Our Ref: 1731C/PJ/07112014a

7 November 2014

Re: Response to Submissions for Proposed Expansion of Tinda Creek Sand Quarry

Figure 1 – Modelled Final Landform Domain 3 Extraction

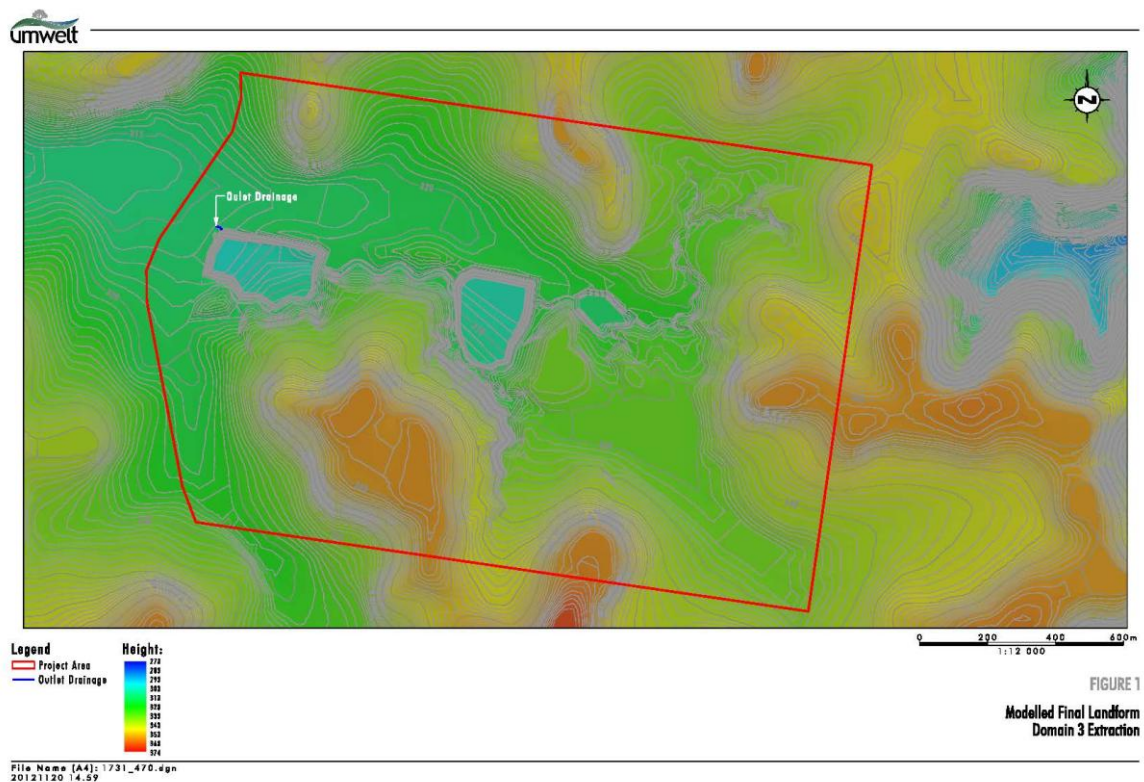
1.1 Final Landform

Perspective 3D views of the conceptual final landform including ponds for extraction within Domain 3 and Domain 7 are shown in Figures 4.10a and Figure 4.10b of the EIS respectively. Plan views of the Domain 3 extraction and Domain 7 extraction conceptual final landforms are shown on **Figures 1 and 2** respectively.

If quarrying is undertaken in Domain 3 rather than Domain 7, it is proposed that quarrying would progress from the existing dredge pond to Domain 6 and Domain 2, followed by Domain 1. Once dredging is completed in Domain 1, the dredge would be disassembled and moved to Domain 3 which would be the last area to be quarried. As shown on Figure 4.10a and **Figure 1**, ponds would be created in Domain 6 and Domain 1, with the Domain 3 progressively backfilled to form a valley that drained to a pond within the existing quarry area. The pond within the existing quarry could be shaped to either discharge to the existing alignment of Tinda Creek or

overflow to the pond in Domain 6. The size and depth of the ponds would be varied depending on the volume of ENM and VENM that is back loaded to the site.

Plate 1 – Drainage and Swamps Near Tinda Creek Quarry

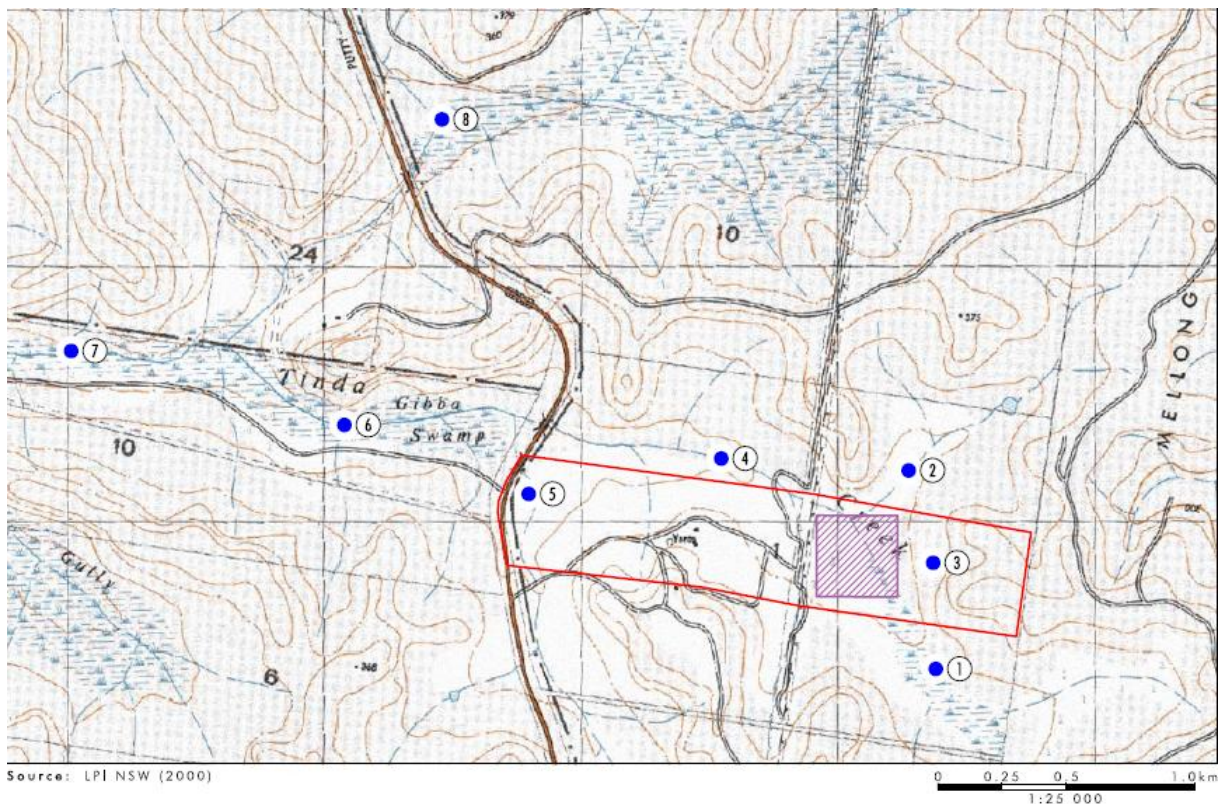
The eight aquatic survey reference sites established in 2007 and discussed in NSW Office of Water's submission are shown on **Plate 1**. The site is located at the top of Tinda Creek catchment. Creek and drainage lines on the site and the surrounding area are intermittent and flow for very short durations after rainfall. As a result, there

As shown on **Plate 1** which is an excerpt below from Figure 1.1 of 'Results of Ecological Condition Assessment and Monitoring, Tinda Creek' (Umwelt May 2008), there is a large swamp (denoted Site 8 at its western end on **Plate 1**) approximately 2 kilometres by road north of the quarry entrance off Putty Road. This swamp is sign posted on Putty Road as Gibba Swamp whereas the signposting on the creek crossing just north of the quarry entrance says Tinda Creek. In regard to Site 8, Umwelt (2008) states:

Directly above the culvert under Putty Road at Site 8, the tributary comprises a broad open channel densely vegetated with emergent macrophytes such as cumbungi (*Typha orientalis*) as well as a diversity of introduced plant species. No substantial build-up of sediment was observed at the culvert. Approximately 200 metres upstream of the culvert the channel becomes more defined and is drier, the vegetation is more complex and there are fewer introduced species. The floodplain of the channel is characterised by a sedgeland similar to that occurring at Sites 1 and 2. It is estimated that this sedgeland occupies an area of approximately 80 hectares.

The sedgeland shown to the east of Site 8 on the excerpt below is extensive (80 hectares) and is believed to be the Gibba Swamp referred to in ecology surveys of the area not the area immediately downstream of the Tinda Creek culverts on Putty Road as shown on the Land and Property Information 1:25,000 series topographic series maps which form the base data for the excerpt shown in **Plate 1**.

Plate 2 – Groundwater Bore Locations

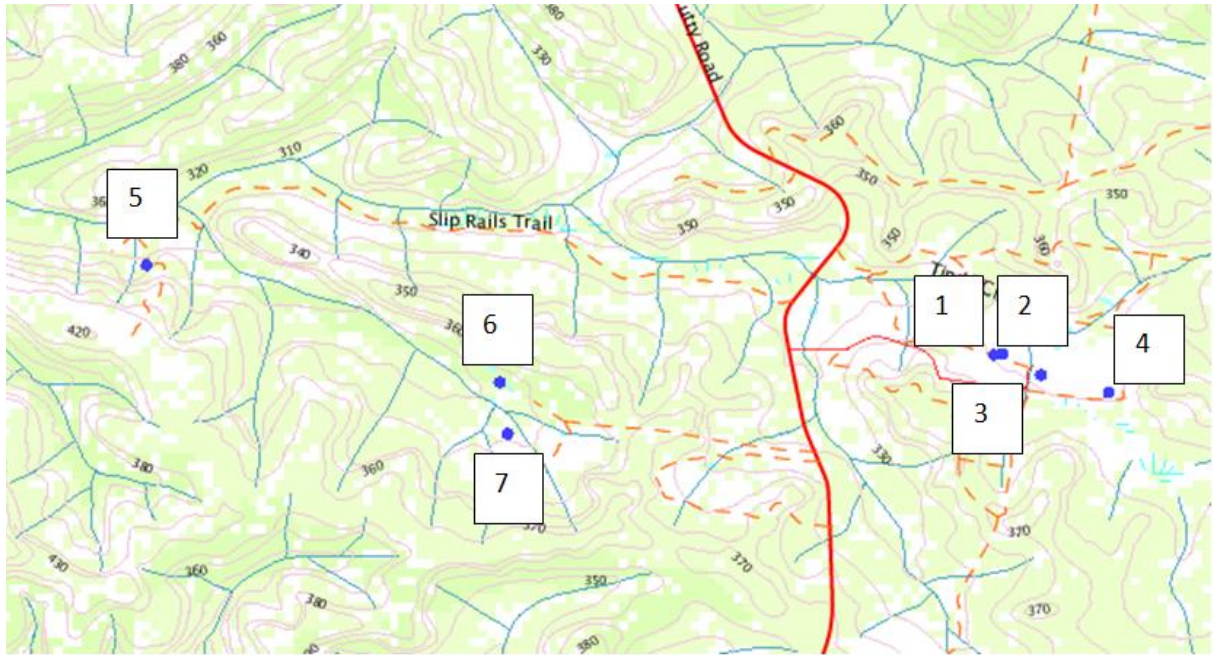
NSW office of Water requested clarification as to the volume of surface and groundwater that will be taken, volumes to be licensed and baseflow losses. This is addressed in **Sections 1.3 to 1.5** above.

As shown on **Plate 2** which is extracted from the NSW Natural Resources Atlas, there are 7 registered groundwater bores in proximity of Tinda Creek quarry. Bores labelled 1 to 4 (GW 110882, GW 110881, GW 110879 and GW 110880 respectively) on **Plate 2** are quarry production bores. The bore labelled 5 (GW 071916) is located off Slip Rails Trail approximately 2.7 kilometres from the western extent of the proposed quarry. Bores labelled 6 (GW 104020) and 7 (GW 111885) are located approximately 1.5 kilometres west of the proposed quarry extension.

From the available groundwater bore information, the regional groundwater level is between 18 and 28 metres below the ground surface with the greatest yield coming from the two production bores at the quarry site (GW 110879 (4 L/s) and GW 110880 (3.5 L/s)). Groundwater bore GW 111885 which is approximately 1.5 kilometres west of the proposed quarry has a reported standing groundwater level of 28 m below ground level and a yield of 2.5 L/s. No ground water level or yield information was available for groundwater bore GW 104020 indicating that it is possibly dry. Groundwater bore GW 071916 is approximately 2.7 kilometres west of the proposed quarry, has a reported standing groundwater level 21 metres below ground level and a low yield of 1 L/s.

Groundwater bores GW 071916, GW 104020 and GW 111885 are in a different catchment to the quarry operations on Tinda Creek and upstream of the confluence of Rising Fast Gully (see **Figure 3**) with Tinda Creek and are therefore unlikely to be influenced by the minor changes in flow that are predicted for Tinda Creek.

Figure 4.1 - Proximity of Project Area to World Heritage Area and National Park

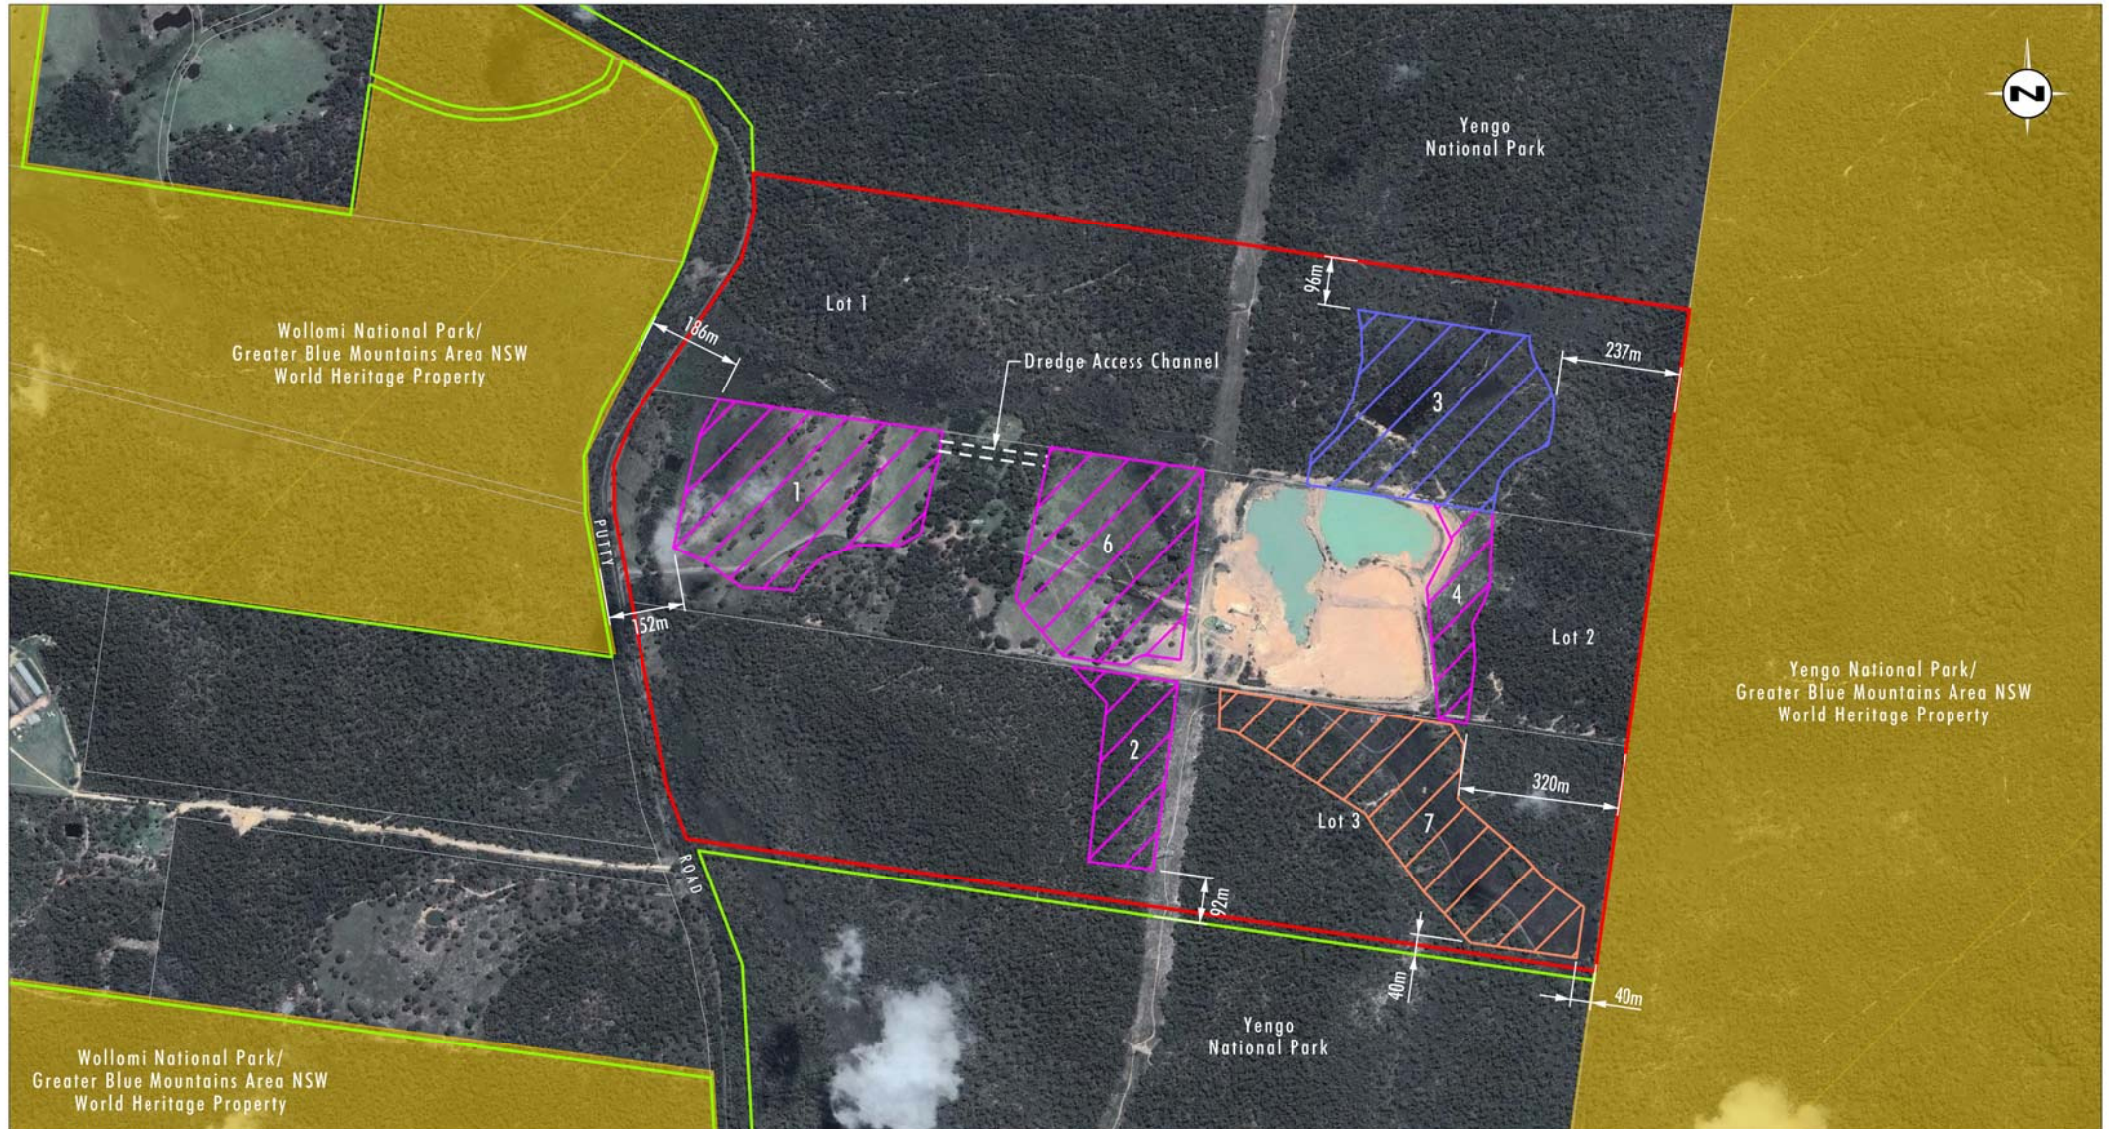
In addition, OEH notes the statement at 4.9 of the EIS that extraction operations will be setback from the Greater Blue Mountains World Heritage Area (GBMWH) by a 'minimum of 237, and Yengo National Parks (YNP) by '40m if domain 7 is quarried' which does not correlate with figure 4.1 indicating a 14m setback. The potential impacts on the values of the GBMWH and YNP arising from this significantly reduced setback have not been addressed in the EIS.

Hy-Tec has incorporated a minimum 40 m buffer zone (associated with the Alternative Project and Biodiversity Offset Strategy; 237 m buffer is included in the Proposed Project) between the Project components and the National Park boundaries in order to minimise the potential for in-direct impacts to the conservation and recreational value of Wollemi and Yengo National Parks. Figure 4.1 of the EIS shows one buffer labelled as 14 metres rather than 40 metres. This is an error and has been corrected as shown on the revised Figure 4.1 which is provided at **Attachment B** to this Response to Submissions.
